Errata

TMS320F2802x, TMS320F2802xx MCUs Silicon Revisions B, A, 0

Figure 4-1. Undesired Trip Event and Blanking Window Expiration

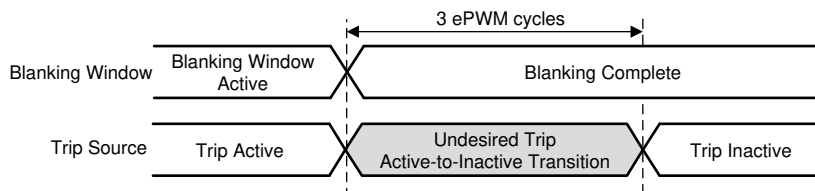
The blanking window is typically used to mask any PWM trip events during transitions which would be false trips to the system. If an ePWM trip event remains active for less than three ePWM clocks after the end of the blanking window cycles, there can be an undesired glitch at the ePWM output.

Figure 4-1 illustrates the time period which could result in an undesired ePWM output.

Workaround(s) Extend or reduce the blanking window to avoid any undesired trip action.
